ORIGINATION FORM

Proposed Revisions to a Standard Plans Index
(Please provide all information — Incomplete forms will be returned)

Index Number: 700-120

Index Title: Enhanced Highway Signing Assemblies

WITHOUT AUXILIARY POLE

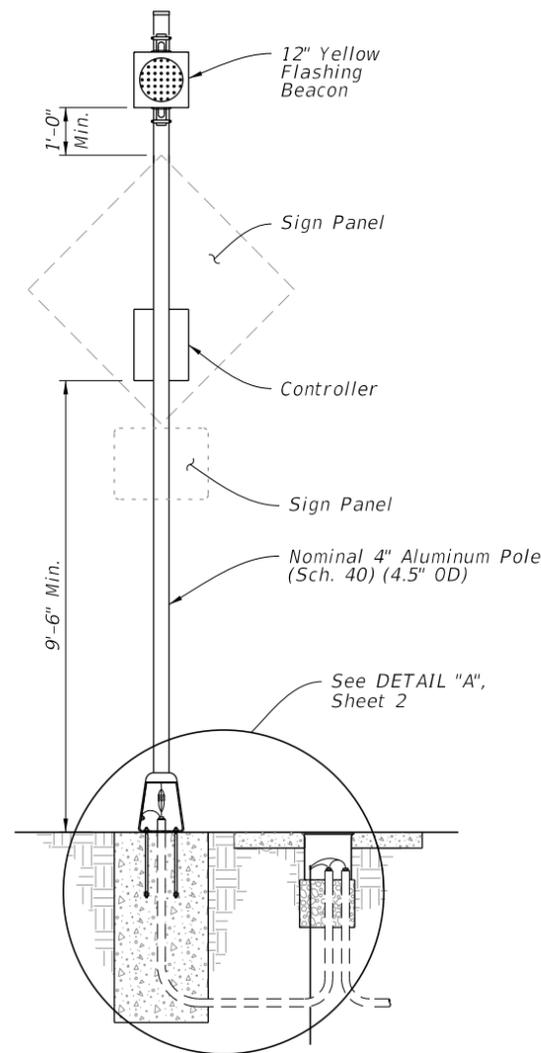
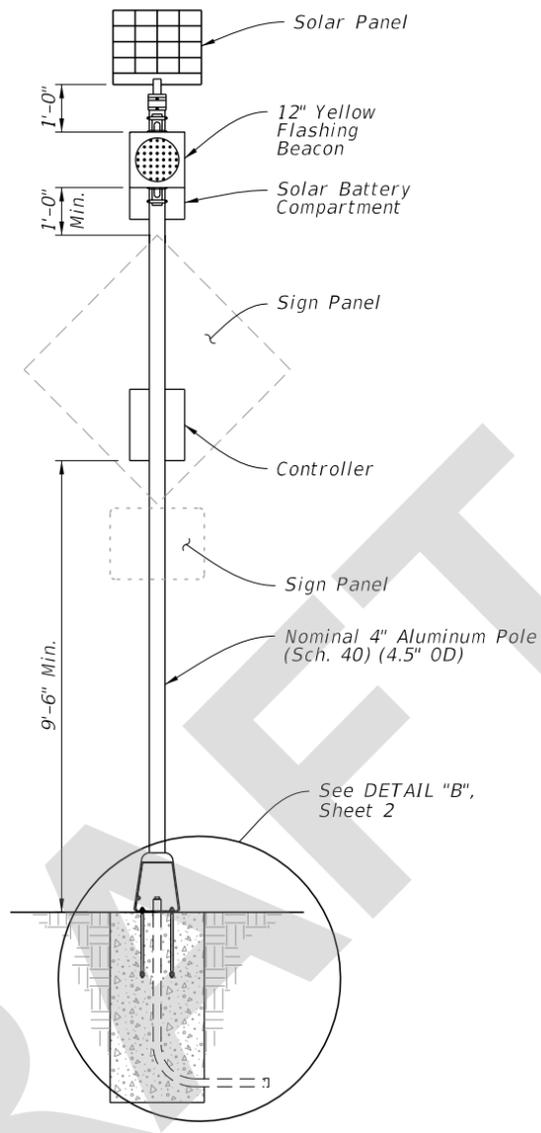
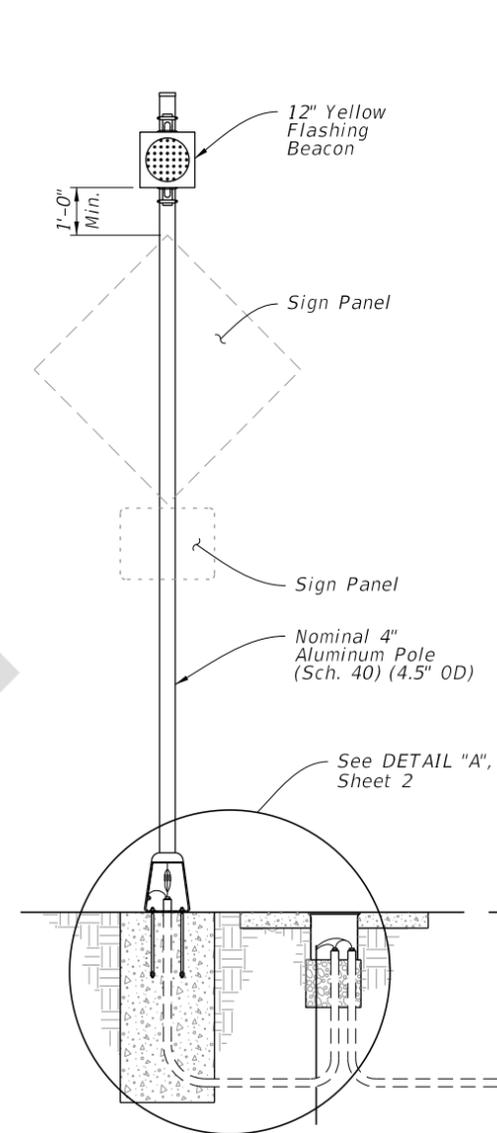
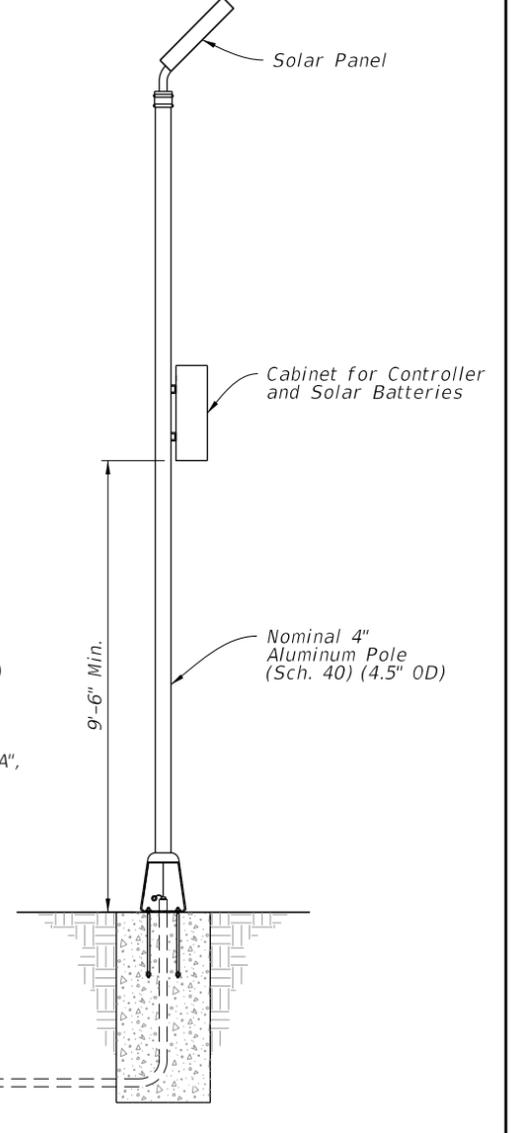
Sheet 1: Deleted the ground wire from the FRONT VIEW in the WITHOUT AUXILIARY POLE.

ROADSIDE SIGN ASSEMBLY-8

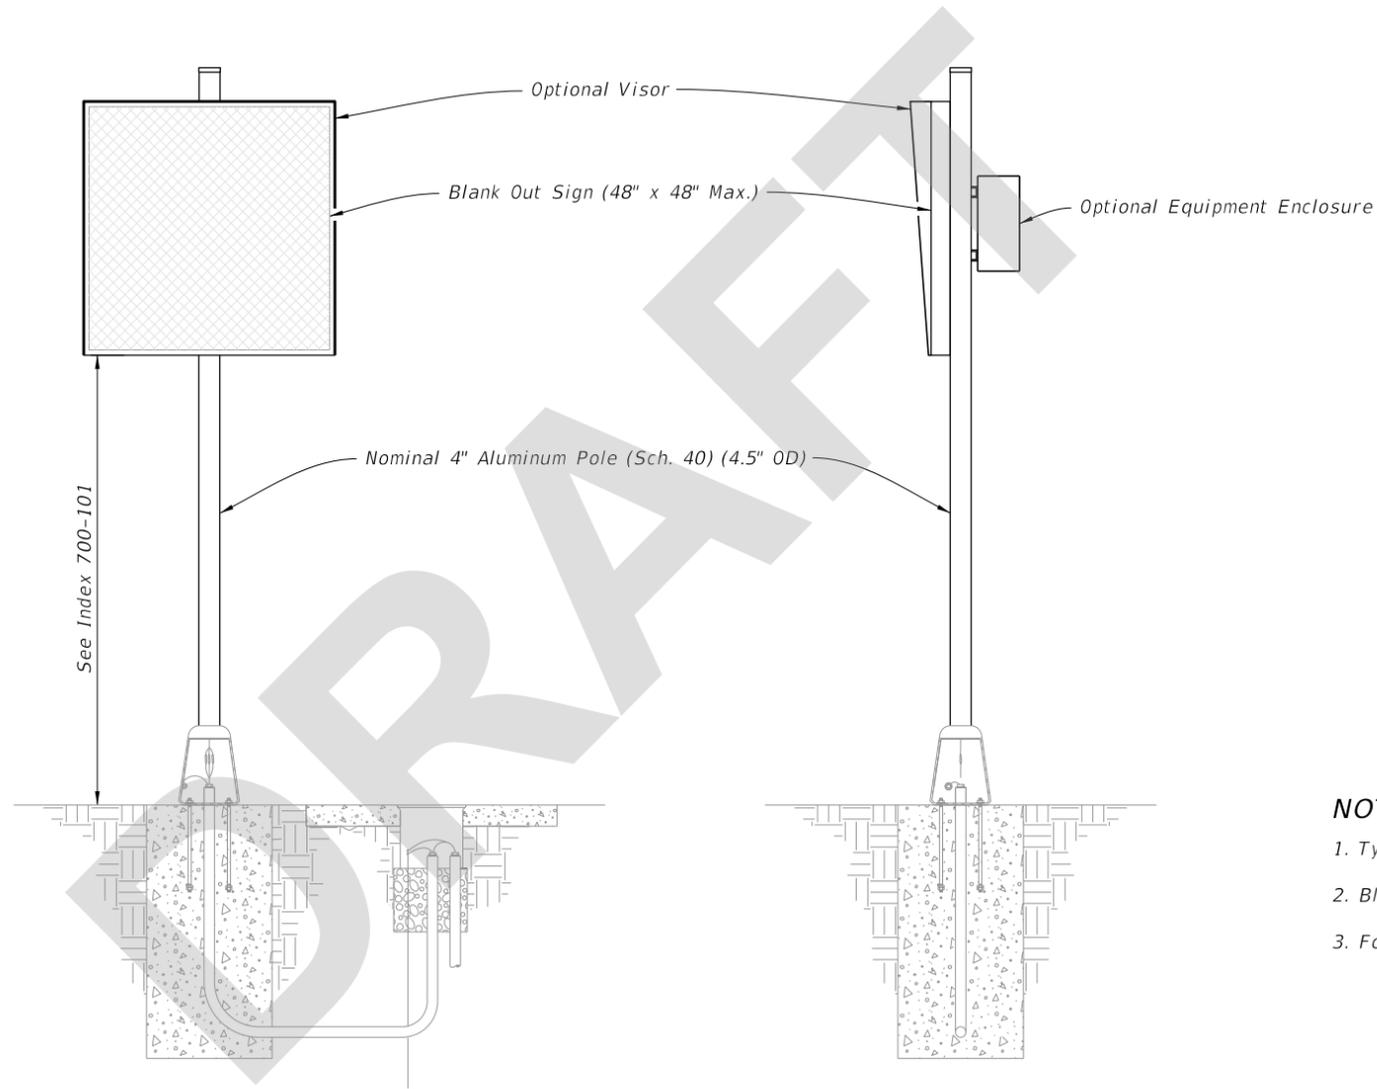
New Sheet 10 - New sheet for Roadside Sign Assembly-8, Blank Out Signs.

New Sheet 11 - Traditionally, Blank Out signs have been installed on traffic signal mast arms. To allow flexibility in installation, the roadside mounting option is being proposed.

- NOTES:**
- 1. Type A1 Assembly (conventionally-powered) is shown.
 - 2. Blank Out Sign visors are optional.
 - 3. Foundation reinforcement not shown.
